# UNITED STATES PATENT AND TRADEMARK OFFICE

<b>Office Action Summary</b>	Application No. 10/692,828	Applicant(s) DICKINSON ET AL.	
	Examiner Ruth C. Rodriguez	Art Unit 3677

## **DETAILED ACTION**

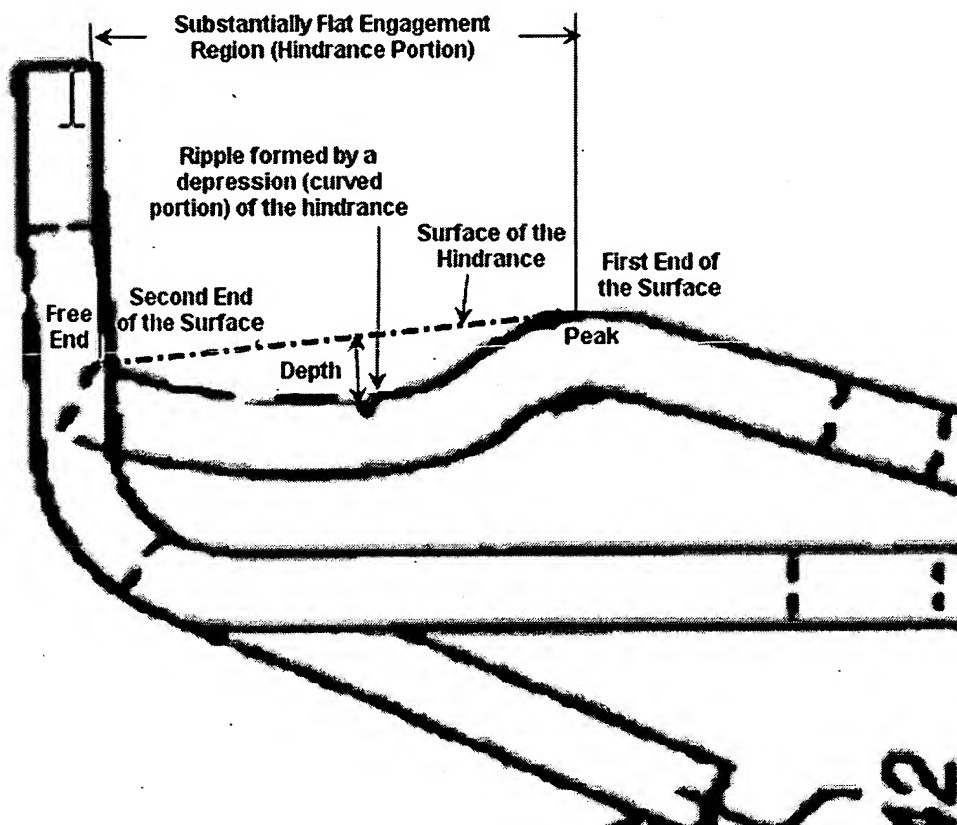
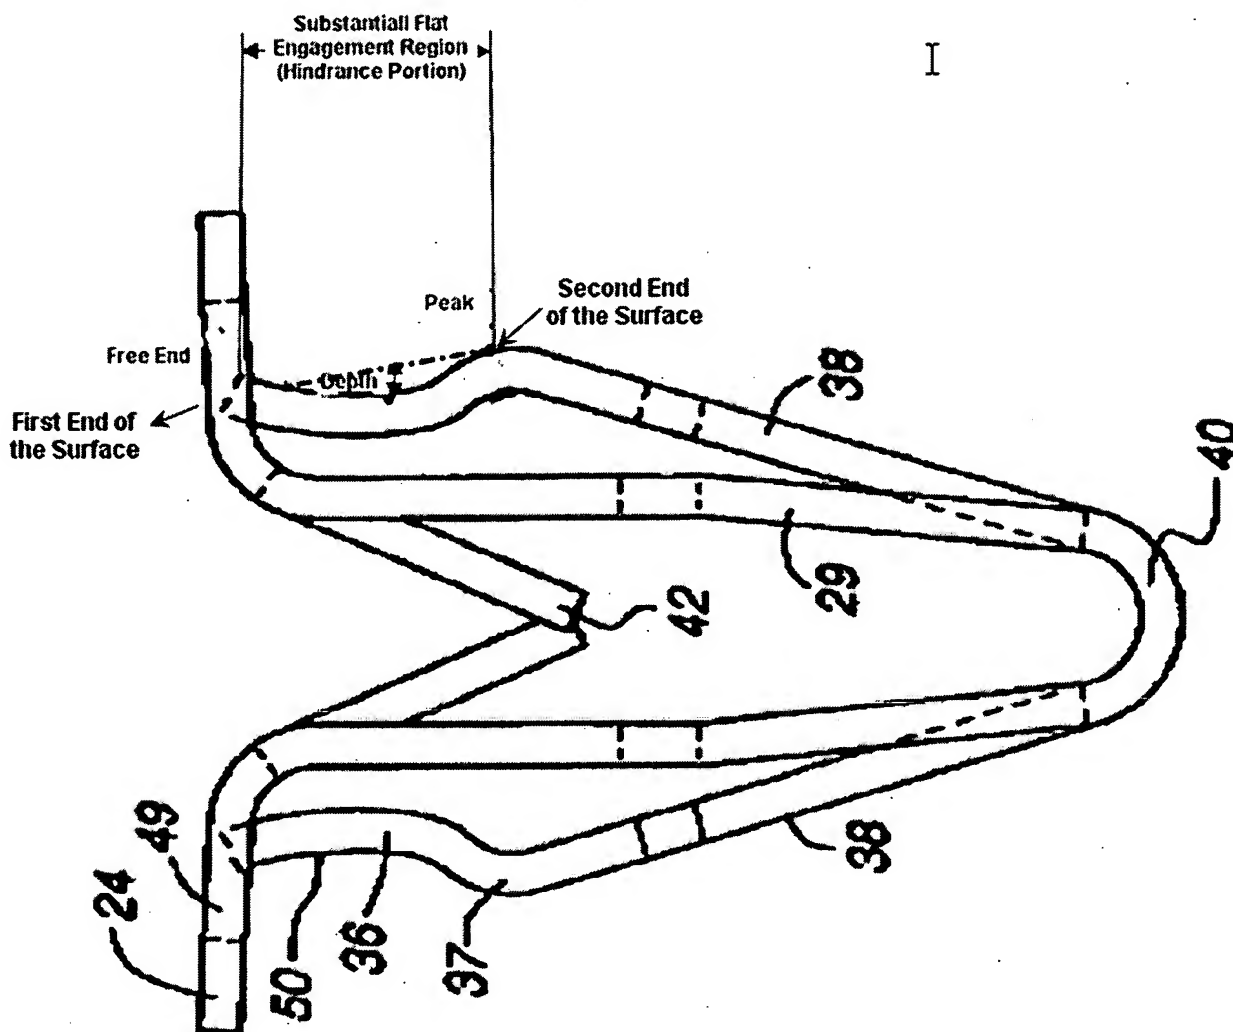
14. The first argument is that Benedetti fails to disclose "the depth of each ripple is the distance between the surface of the hindrance portion and the deepest part of the respective ripple" since Benedetti discloses a curved portion having the same thickness. This argument fails to persuade. The claims only require that "a substantially flat portion" that is between the peak and the free end just as shown in the figure above. The curved portion disclosed by Benedetti can be considered the ripple since the claim does not include any limitation that there is a curved portion between the free end and the peak in addition to the hindrance portion. The surface is defined, in the figure, by the free end and the peak. Therefore the claim limitations are met when the depth of each ripple is considered as the distance between the surface (defined only by the part of the hindrance that is next to the peak and the free end) and the deepest part of the respective ripple (lowest part of the curve). The Applicant argues that the spring has the same thickness throughout with no ripples. The Examiner fails to persuade by this argument because the claim does not define what parameters are being used to define the thickness. This argument could be persuasive if the claims define that the thickness is defined between a side of the engagement spring that is facing outwardly away from the other engagement and an opposite side of the engagement spring that is facing inwardly towards the other engagement spring and the ripples create an area of reduced thickness with respect to the rest of the hindrance portion.

16. The next argument about what is considered as the recess is not persuasive because the claims are not reciting "a recess". The Examiner was using the term recess to refer to the curved portion that extends between the free end and the peak. However, the current figure clearly labels the surface of the spring that is considered as the ripple.

17. The Applicant argues that the office action fails to point out the ripple, hindrance portion, depression and the depth. The Examiner fails to be persuaded by this argument. As illustrated above and explained before, the hindrance is the entire surface that extends between the peak and the free end. The surface is defined only by the ends of the hindrance that are located next to the peak and next to the free end. The ripple is the rest of the curved portion that extends between the free end and the peak. The ripple is defined by the curved portion that is formed when a depression is provided between the free end and the peak. Finally, the depth is the distance that is defined between the surface (either at the free end or at the peak) and the lowest part of

the ripple (portion of the curved portion that is furthest away from the free end or the peak).
